STAFF REPORT: DECEMBER 13, 2023, REGULAR MEETING
Revised December 12, 2023, to include additional information on finishes

APPLICATION NUMBER: HDC2023-00133

ADDRESS: 7810 KERCHEVAL (ALSO KNOWN AS 1826 SEYBURN)

SCOPE: ERECT ADDITION CONNECTING DWELLING AND COMMERCIAL BUILDING, REMOVE REAR PORCH AND STAIRWAY ENCLOSURE, RESTORE FRONT PORCH, ALTER DORMERS

Rendering of proposed work viewed from Kercheval. Image from application documents.

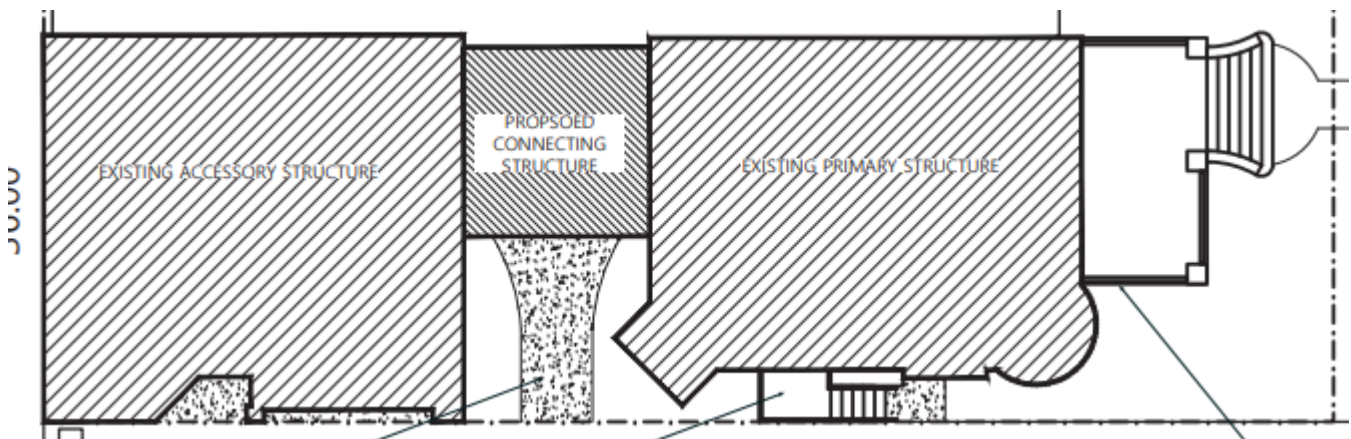
- The massing, height, fenestration pattern, and material of the proposed addition render it compatible with the adjoining historic buildings. Its dark color and recessed placement cause it to visually recede to avoid distracting from the historic buildings. While an entrance is located on the addition, its location behind a projecting bay of the historic house helps to deemphasize its prominence. These qualities satisfy Standard #9: “The new work shall be differentiated from the old and shall be compatible with the massing, size, scale, and architectural features to protect the historic integrity of the property and its environment.”

- *New Exterior Additions to Historic Buildings: Preservation Concerns* (Preservation Brief 14) elaborates upon the requirements of Standard #9. Suggested design approaches including “incorporate a simple, recessed, small-scale hyphen” and “avoid designs that unify the two volumes into a single architectural whole” are effectively incorporated in the design of the proposed addition.

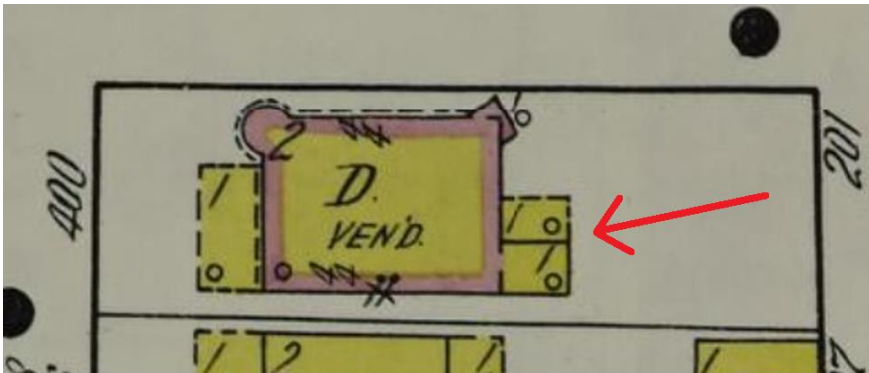
- The addition will require the removal of a rear (east-facing) projection from the house. In plan, this projection consists of two distinct elements. The north half (closest to Kercheval) of the projecting area is a true porch, likely to have originally been of a similar brick and wood composition as the front porch, but enclosed at some point in the building’s early history. The south half (furthest from Kercheval) is a stair enclosure connecting a rear door on the building’s first floor with a bulkhead door accessing the basement. Together, these areas are enclosed with the same beadboard cladding, suggesting the alterations were

- In general, porches are character-defining features; their removal is contrary to the Standards. In this case, however, the character of the porch has already been diminished by dramatic alterations; further, the historical relationship between the porch and the former backyard has already been eliminated by the construction of the 1917 commercial building.

- As the house has two-street facing facades, the south elevation closely abuts an adjacent building, and the rear of the house features a distinctive and character-defining angled box bay window, the rear porch enclosure is the only remaining location where an addition could be feasibly accommodated.

- Staff opinion is that the proposed demolition is appropriate in that it facilitates the rehabilitation and continued use of the building while minimizing the impact on character-defining features.
